I-85 SEWER EXTENSION  
CONTRACT 1B – COLLECTIONS

ADDENDUM NO. 6

January 10, 2024

Gaffney Board of Public Works  
I-85 Sewer Extension  
Contract 1B- Collections Broad River  
WWTP to Bear Den SPS

C-03-115A

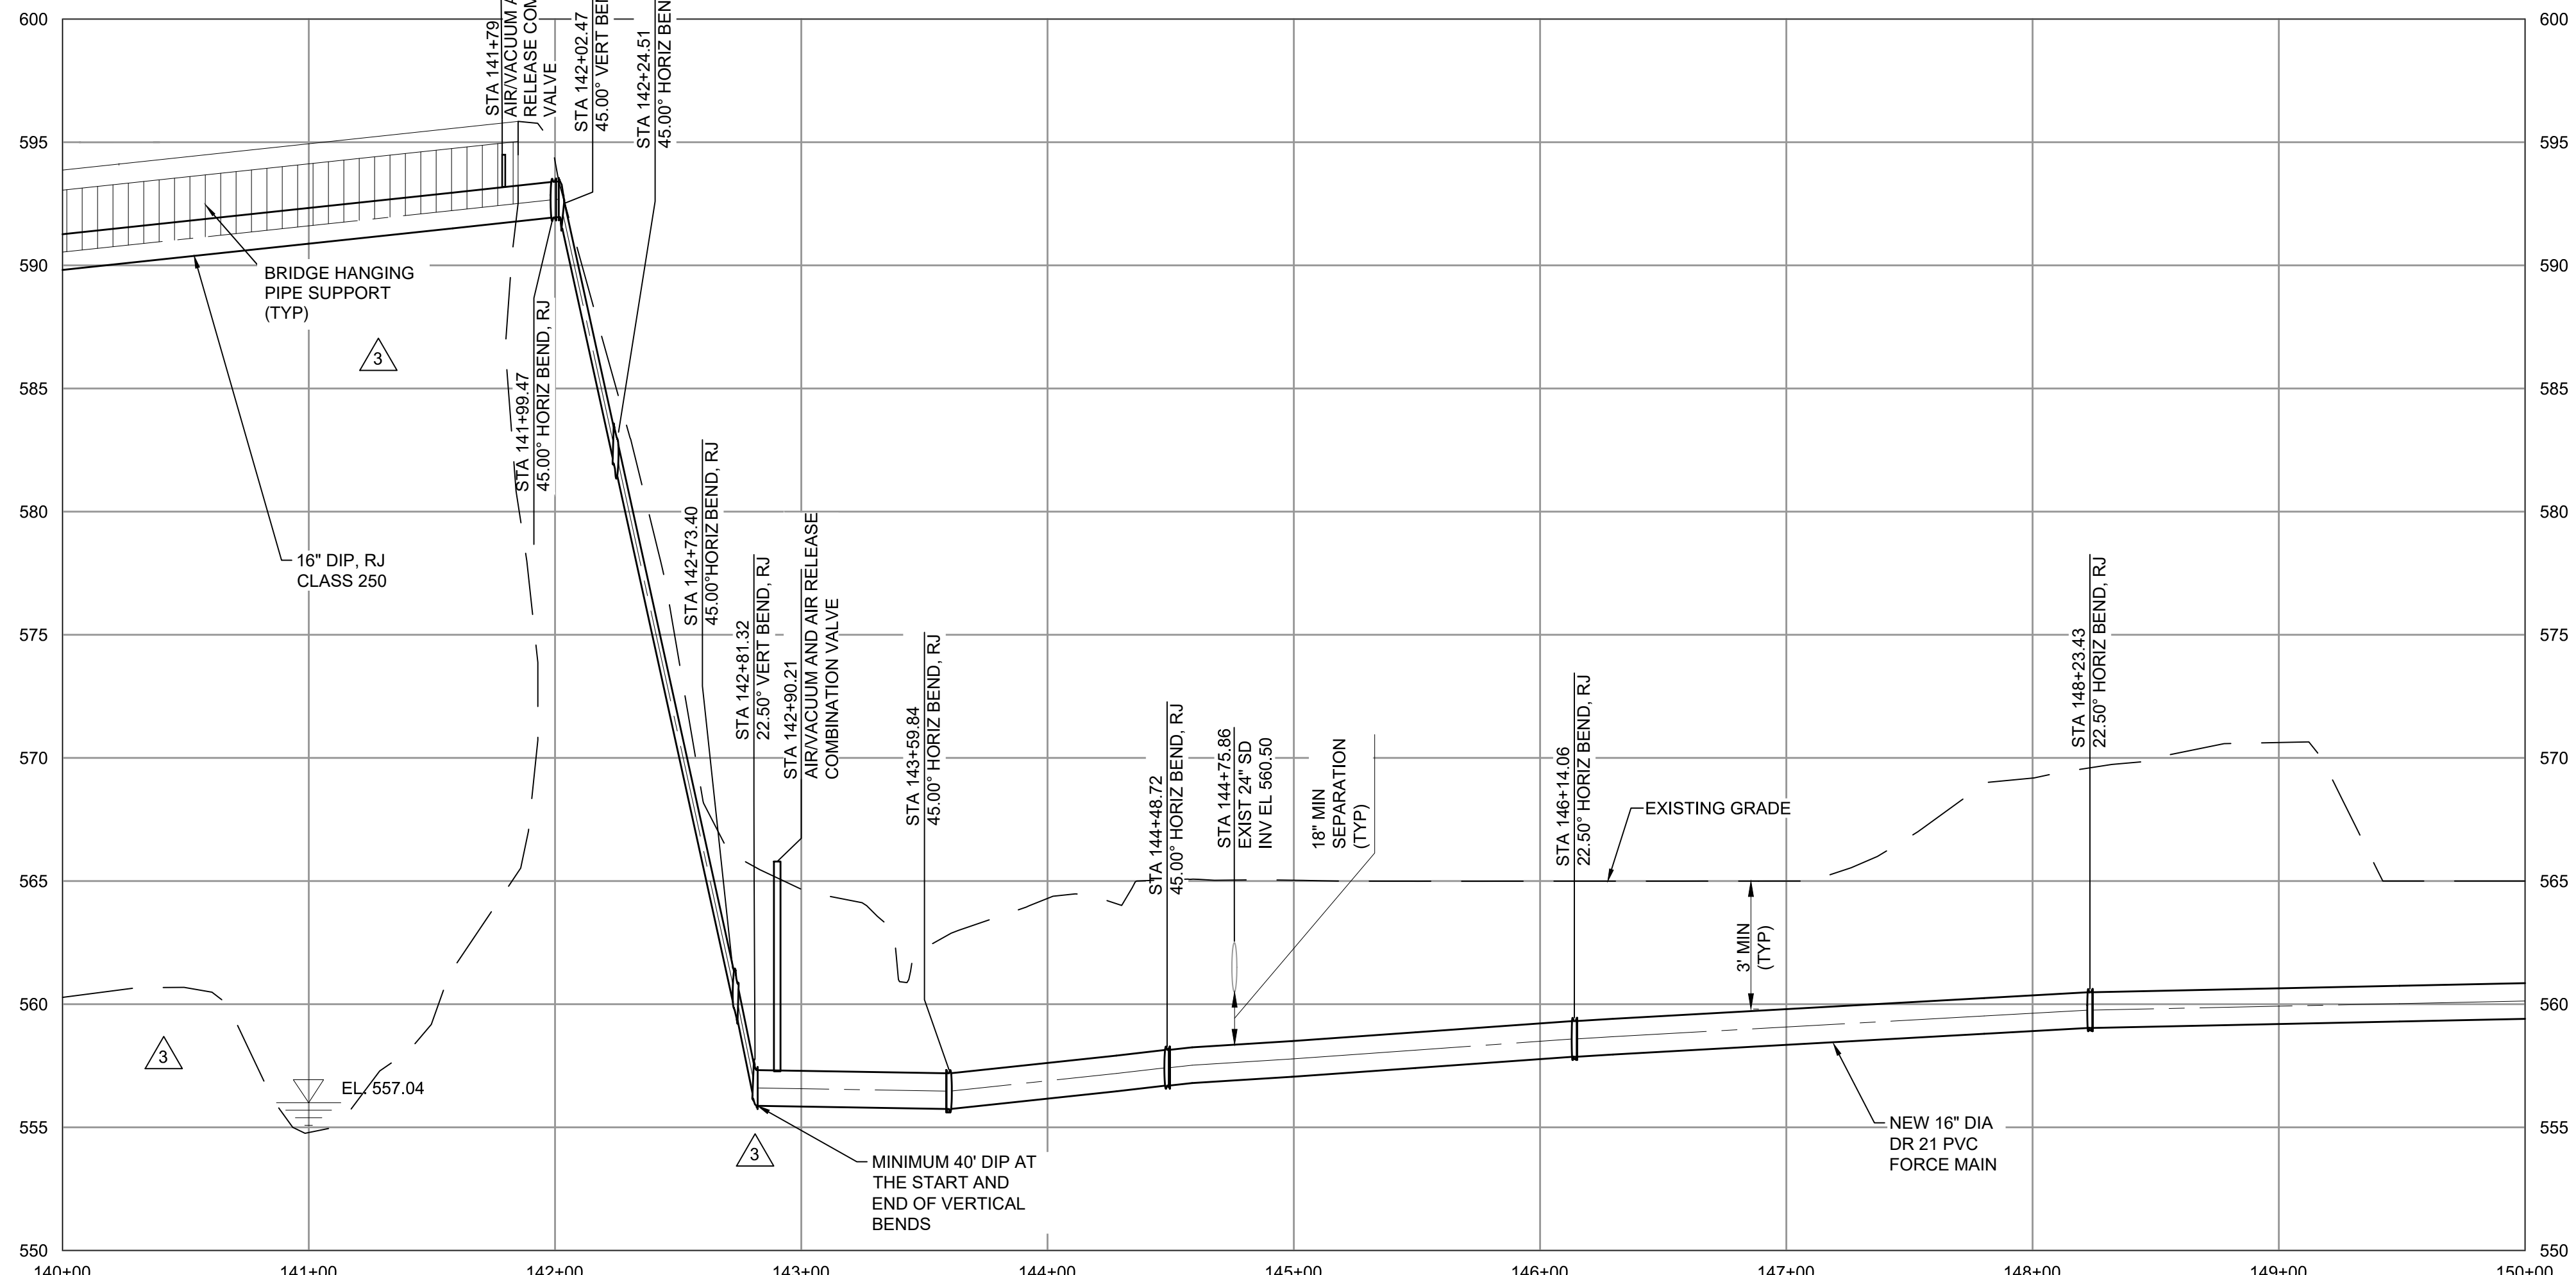
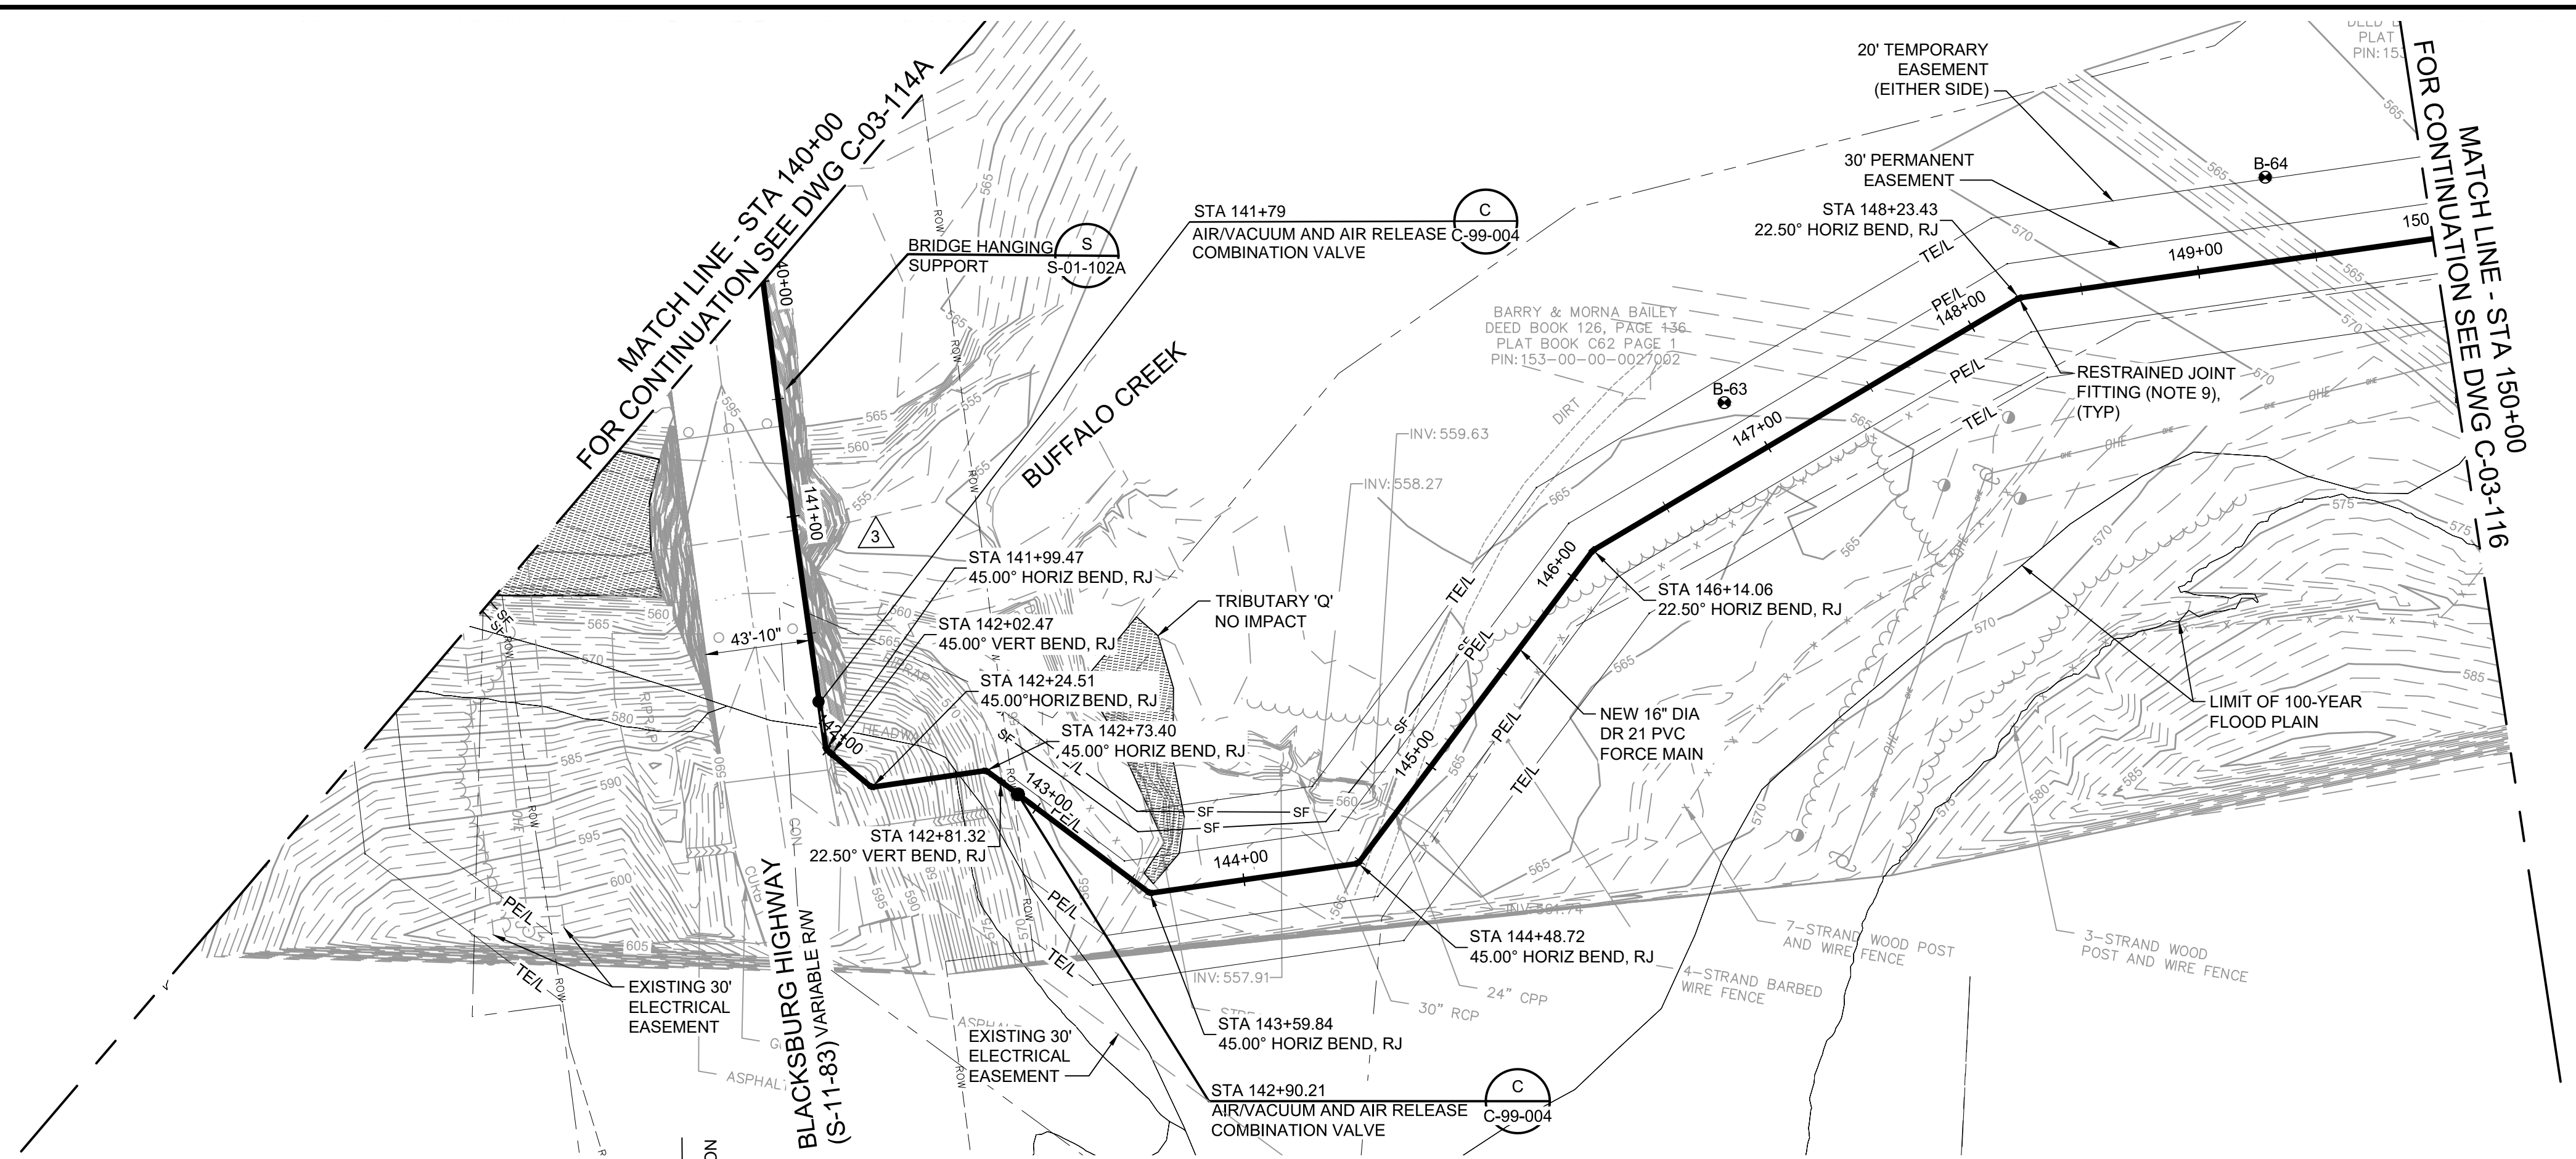
Alternative 2: Removal of Segment 3 horizontal directional drilling and 18” DR 11 HDPE force main under Buffalo creek along

Blacksburg Highway. Installation of 16" DR 21 PVC force main with a 16" DIP, RJ Class 250 pipe hanging along the Blacksburg Highway bridge over Buffalo Creek.

Remove Segment 3 horizontal directional drilling and 18" DR 11 HDPE force main under Buffalo creek along Blacksburg Highway. Install 16" DR 21 PVC force main with a 16" DIP, RJ Class 250 pipe hanging along the Blacksburg Highway bridge over Buffalo Creek.

- i. Insert the attached new sheets C-02-111A and C-02-112A for Segment 2 Alternative 1 and the new sheets C-03-114A and C-03-115A for Segment 3 Alternative 2 after sheet C-03-120.
- ii. Insert the attached new sheets S-00-001, S-01-101A, and S-01-102A for the Alternatives after sheet C-99-006.
